6.2 **97 ALMA ROAD, ST KILDA EAST (PDPL/00823/2022)**
LOCATION/ADDRESS: **97 ALMA ROAD, ST KILDA EAST VIC 3182**
EXECUTIVE MEMBER: **BRIAN TEE, GENERAL MANAGER, CITY GROWTH AND DEVELOPMENT**
PREPARED BY: **DARREN CAMILLERI, PLANNING COORDINATOR CANAL WARD**

1. PURPOSE

- 1.1 To determine an application for the construction multiple dwellings on a lot and construction of buildings and works for a Section 2 use of the land as a 'food and drink premises' in the General Residential Zone, and the construction of works in a Special Building Overlay, and a reduction in the number of car parking spaces required by Clause 52.06 of the Planning Scheme.

Figure 8: Site plan showing interface to east (TP002 dated 27.07.2023)

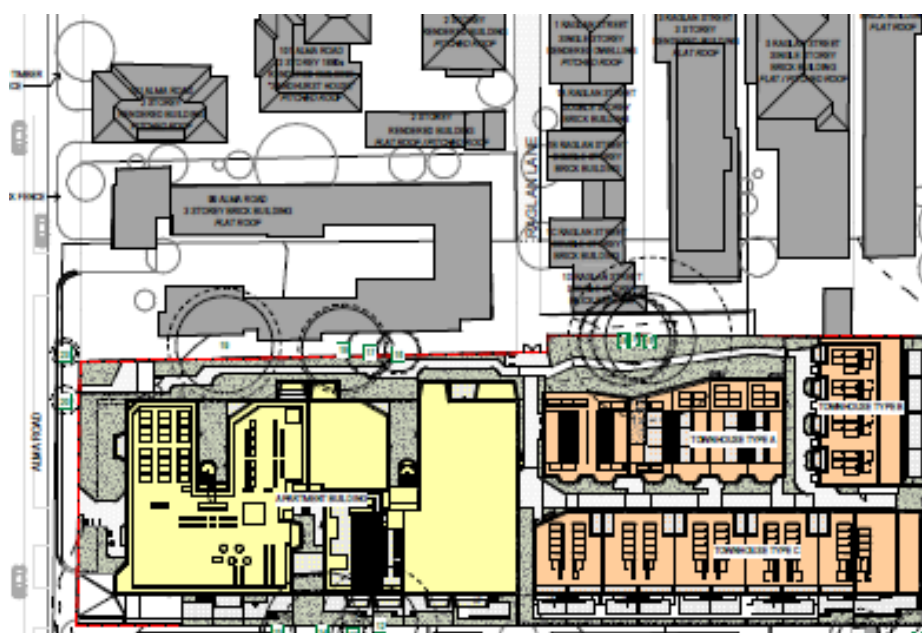
The proposal has responded appropriately to the eastern interfaces.

- An objector referred to the lack of detail on the appearance of the gates and pedestrian entry from the lane. This information should be required and forms a permit condition of the officer recommendation.

- f) Details (elevation plan, material, colour) of the gate and pedestrian entry from Raglan Lane.
- g) All upper level balconies with views to adjoining secluded private open space or habitable room windows within a 9m distance are screened and/or obscured in accordance with Standard B22 (Overlooking Objective) of Clause 55.04-6 of the Port Phillip Planning Scheme. This may require provision of additional detailed overlooking diagrams and sections to demonstrate compliance. Screening and/or obscuring information on elevations and floor plans must be consistent.

Figure 9: Site layout adjacent to southern boundary (TP002 dated 27.03,2023)

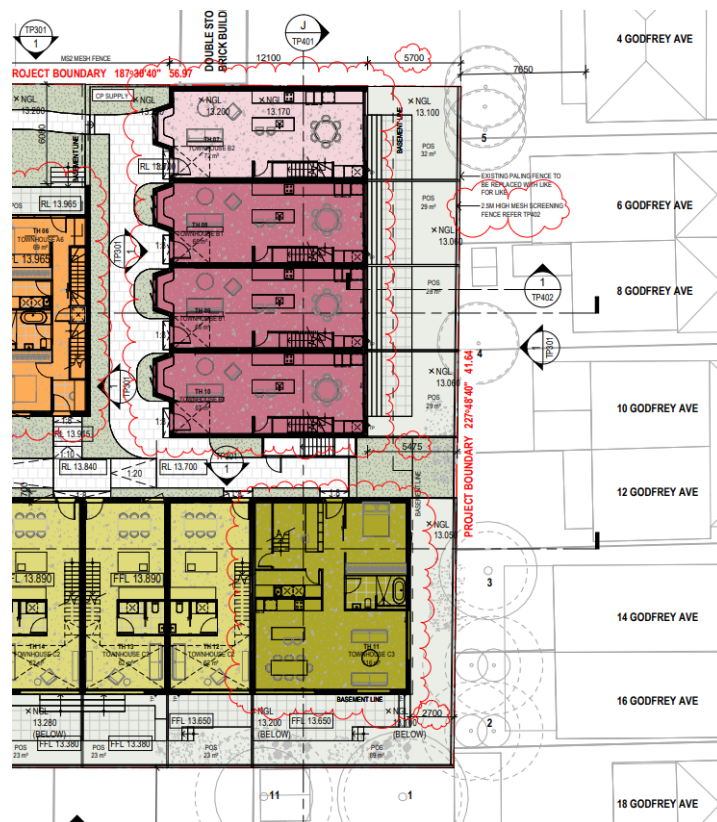
There were multiple objections about the proposed interface to the south as shown on the originally advertised layout. The current layout incorporates increased setbacks at all levels to TH7-10 and deletes boundary construction associated with TH11.

- Setbacks that exceed the standard and provide a sense of space between the development and the adjoining properties.
- The setback of the upper level of the three storey town houses and the two-storey nature of TH11 creates a transition in built form to the single storey development to the south and provides articulation in the built form. These features combine to avoid unreasonable visual bulk when viewed from the south.
- There is opportunity to landscape along the southern boundary with the landscape plan showing planting of 12 trees along this boundary.
- The gap between TH11 and TH10 that ensures continuous built form is avoided to the south elevation.

Figure 10: Mesh fencing and mesh screening detail MS2 mesh fencing to the left and MS3 mesh screening to the right (TP800 dated 27.07.2023)

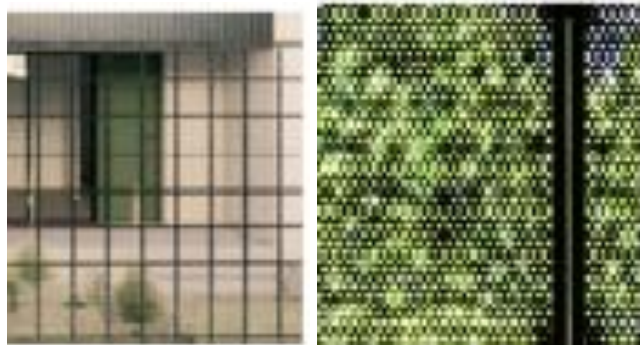
Objections to originally advertised plans raise concern about the shadow and visual bulk impact of proposed mesh fencing to boundaries to the south and west. Two objections lodged to the current plans raise concern that the proposed mesh fencing along the southern boundary is not detailed in plans and may result in shadow, depending on design as wall planting to the mesh. It is requested that the fence be lowered to 2m. The materials palette plan shows two mesh details as shown in Figure 10 below.

The plans include reference to 'mesh screening fence' to the south and west boundaries but are unclear about which type of mesh is proposed. A condition of the officers recommendation requires the use of MS2 'mesh fencing' to ensure the fencing is relatively open. The request to lower the mesh fence adjacent to 14 and 16 Godfrey Street is also a permit condition contained in the officer recommendation. However, it is considered inappropriate to alter the height proposed to other boundaries since the same request was not received from other property owners. The proposed open style mesh fence with future planting behind the boundary fencing will minimise the shadow and bulk impacts associated with a solid fence.

- t) A notation on all external openings down to the basement that these openings must be watertight
- u) 'MS2' mesh fencing along the south and west boundaries.
- v) The mesh fencing adjacent 14 and 16 Godfrey Street lowered to 2.0 m.
- w) Any changes or notations to the plans as recommended by the acoustic report required pursuant to Condition 5.
- x) Urban Art in accordance with the requirements of Condition 9.
- y) Any changes to the plans to accord with the amended Sustainability Management Plan required pursuant to Condition 10.
- z) Any changes to the plans to accord with the amended landscape plan required pursuant to Condition 19.

Figure 11: Light coloured bagged brickwork and light grey painted finish (TP800 dated 27.07.2023)

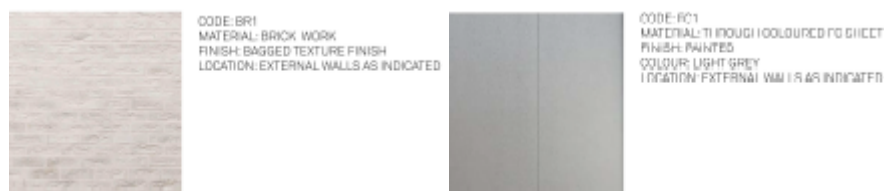
Concern was raised about the external finishes of the south elevation with a request made in objections for the render to be white. The proposed finishes and colours shown – a light coloured textured bagged wall for the lower two levels and a light grey painted wall for the upper-level shown in Figure 11 below – present a neutral appearance and are acceptable.

Figure13: Vehicle entry at ground level providing access to basement

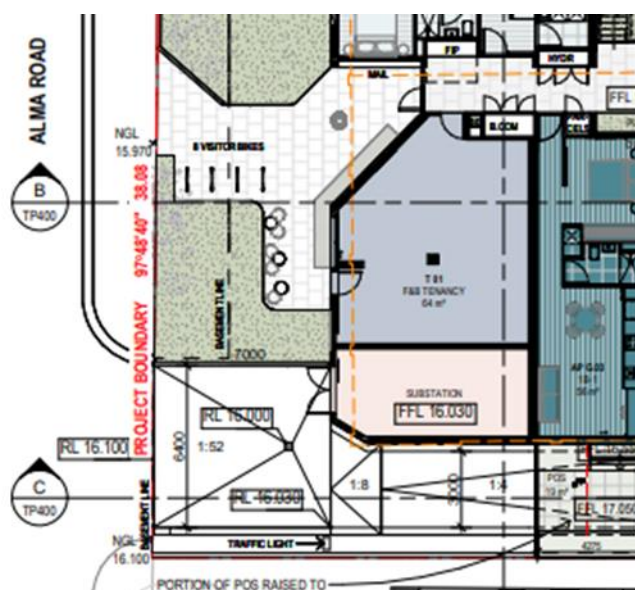
Council's Traffic Safety Engineer has assessed the car parking against the requirements of clause 52.06-9 and is generally satisfied the layout meets relevant design standards subject to three matters being addressed as follows:

- n) Amended basement ramp to avoid encroachment of the 300mm clearance lines for waste truck collection.
- o) Allocation of a commercial garbage bin of a minimum size of 660 Litres or alteration to the Waste Management Plan to require an increase in the frequency of commercial garbage collection for the food and drink premises.

Figure 15: Layout of deck at 3 Graylings Grove, now constructed (provided by objector)

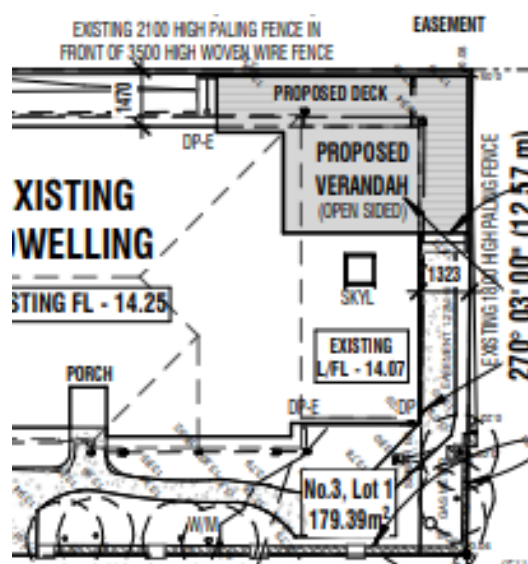
The property at 3 Graylings Grove has recently been renovated to include a covered verandah and deck area adjacent to the review site as shown in Figure 15 below. The open deck area is between 1.3 and 1.4m wide where it adjoins the site. The shadow analysis has not addressed this space. Notwithstanding this oversight, it is considered that the space that is open to the sky adjacent to the boundary at 1.4m wide would already be subject to shadow from the 2.1m high paling fence in the mornings at the equinox and the proposal is unlikely to increase this shadow. It is noted there is an area of spos adjacent to the front boundary of this property (privacy provided by a high front fence).
